Organisation intergouvernementale pour les transports internationaux ferroviaires Zwischenstaatliche Organisation für den internationalen Eisenbahnverkehr Intergovernmental Organisation for International Carriage by Rail

INF. 20

RID: 8th Session of the RID Committee of Experts' standing working group (Utrecht, 20 to 24 November 2017)

Subject: Proposal to amend Part 5 of RID

(No 9A) Symbol (seven vertical black stripes in upper half; battery group, one broken and emitting flame in lower half): black; Background: white; Figure "9" underlined in bottom corner

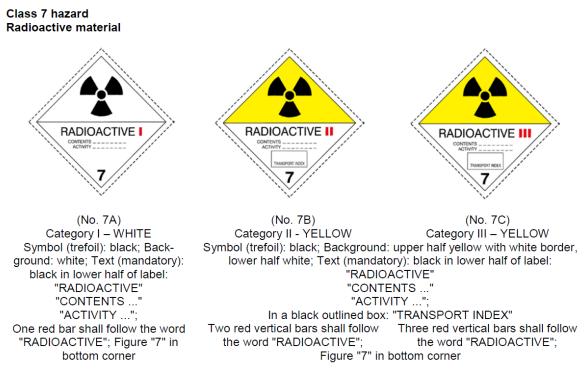
4. Thus, the new label 9A completely falls under the criteria of 5.2.2.2.1.5 - that is, it has the upper and lower half of the symbol, which physically will not allow any optional text to

be placed on it under the symbol (the type of hazard and precautions that are necessary to comply with the handling of goods, UN number).

- 5. In order to exclude the repetition of information in 5.2.2.2.1.3 and 5.2.2.2.2, and to avoid derogating from the structure of the presentation of requirements in 5.2.2.2.1.3 and 5.2.2.2.1.5, we propose that the text of paragraphs 5.2.2.2.1.3 and 5.2.2.2.1.5 be amended as follows:
 - **"5.2.2.1.3** With the exception of labels for Divisions 1.4, 1.5 and 1.6 of Class 1, the upper half of the label shall contain the pictorial symbol and the lower half shall contain:
 - (a) For Classes 1, 2, 3, 5.1, 5.2, 7, 8 and 9⁴, the class number;
 - (b) For Classes 4.1, 4.2 and 4.3, the figure "4"
 - (c) For Classes 6.1 and 6.2, the figure "6".

Symbol of label according to model No. 9A consists of the upper and lower halves (see 5.2.2.2.2).

Except for label model No 9A, tThe Labels may include text such as the UN number or words describing the hazard (e.g. "flammable") in accordance with 5.2.2.2.1.5 provided the text does not obscure or detract from the other required label elements."

"5.2.2.1.5On labels other than those for material of Class 7 and label model No 9A, the optional insertion of any text (other than the Class number) in the space below the symbol shall be confined to particulars indicating the nature of the risk and precautions to be taken in handling."
